**UNITED STATES ENVIRONMENTAL PROTECTION AGENCY  
REGION 8**

**JUN 21 2013**

Re: Draft HiLine Resource Management Plan and Environmental  
Impact Statement, CEQ # 20130065

# Source Water Protection Areas - BLM Hi-Line Area

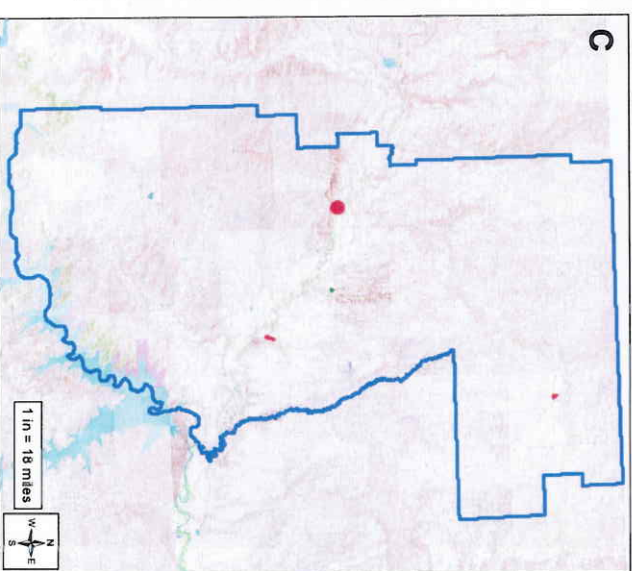
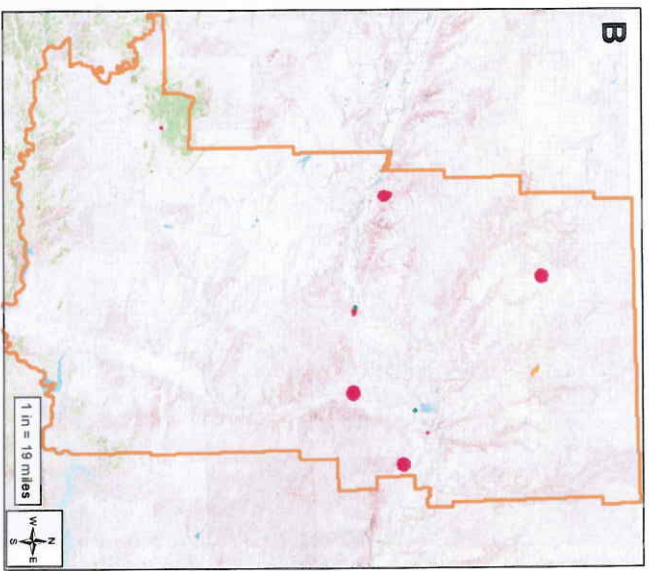
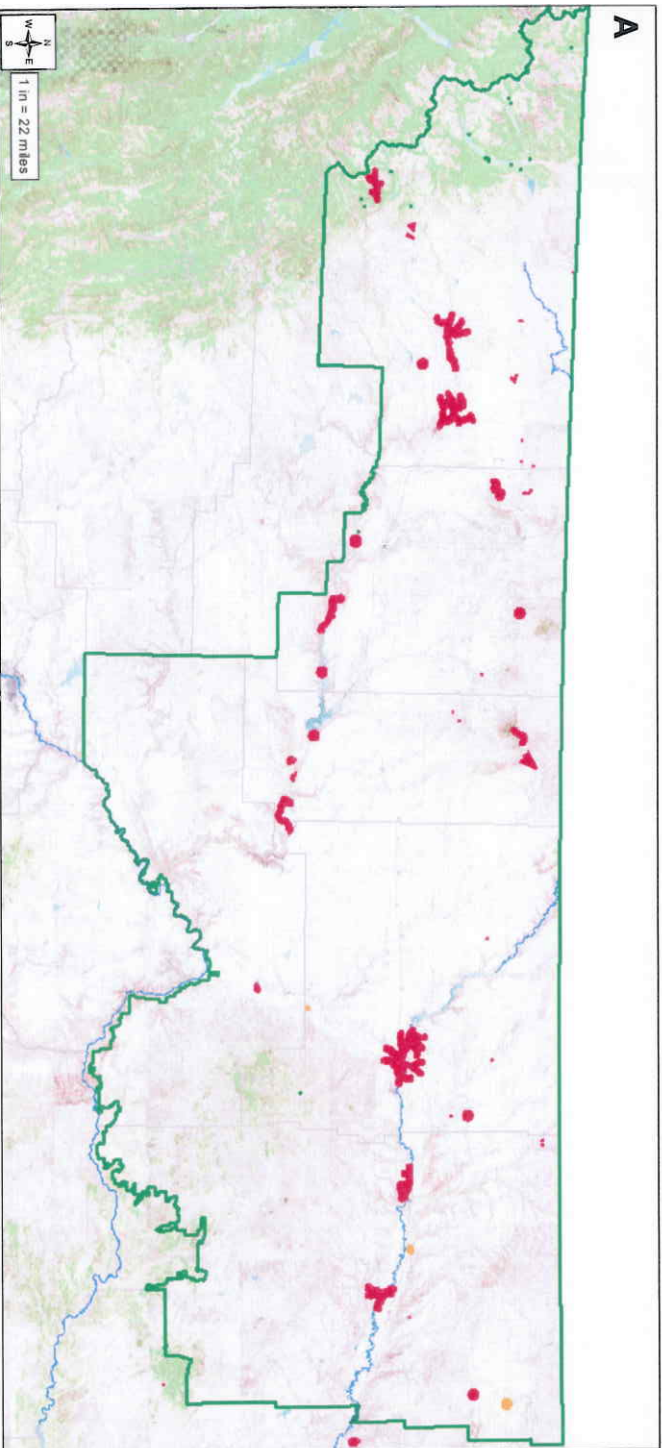
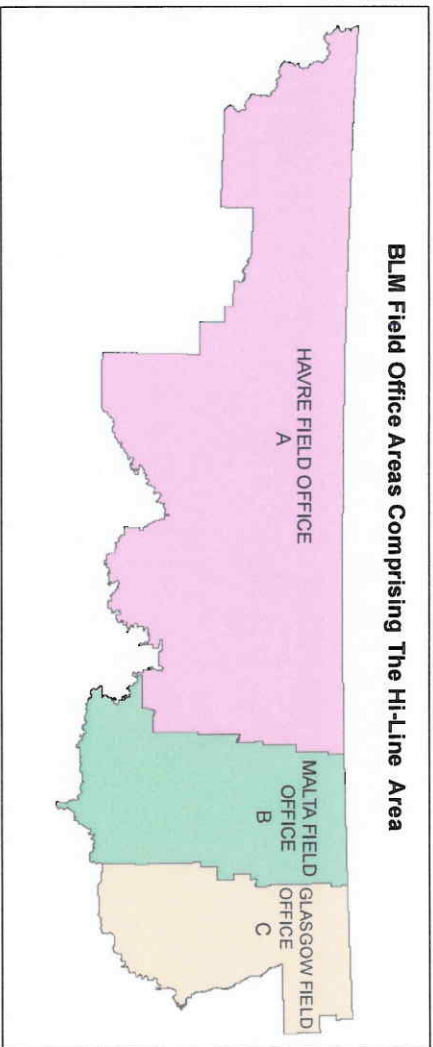
The EPA recommends the following NSO language to help protect these public drinking water supply sources from potential impacts associated with oil and gas leasing:

Municipal Supply Watersheds<sup>1</sup> - NSO within any of the following areas, as deemed appropriate by the BLM:

- The entire watershed; or
- Local Source Water Protection Planning Areas where delineated in a Source Water Protection Plan; or
- Surface Water Spill Response Region or Groundwater Inventory Region defined by Source Water Assessments that have been delineated or evaluated by the State.
  - Surface Water Spill Response Regions are ½-mile-wide zones (on both sides of rivers or streams, upstream of drinking water intakes. They include the water body with the surface water intake and significant tributaries, for 10 miles upstream of the drinking water intake. For lakes and reservoirs, they include a ½-mile-wide zone around the water body.
  - Groundwater Inventory Regions are based on a three-year time of travel or a fixed radius of 1,000 feet (concentric buffer) around the public water supply well.

feasible by the BLM, then at a minimum we recommend a 1,000-foot NSO or CSU setback on both sides of the river or stream, for 10 miles upstream of the intake. For lakes and reservoirs, this would include a 1,000-foot NSO or CSU setback around the water body.

For groundwater and GWUDISW sources, if the Municipal Supply Watersheds NSO stipulation is not deemed feasible by the BLM, we recommend a minimum 1,000-foot CSU concentric buffer for these sources. We make this recommendation based on consultation with Joe Meek, the Source Water Protection Program Manager with the MDEQ. He may be contacted for additional information at 406-444-4806, or [jmeek@mt.gov](mailto:jmeek@mt.gov).

The EPA also recommends the BLM include a commitment in the Final RMP/EIS and ROD to provide notice to lessees regarding these important areas in the HiLine. Lease notices for drilling within Source Water Protection Zones of public water supplies are now being used for all wells drilled under BLM authority in Utah.
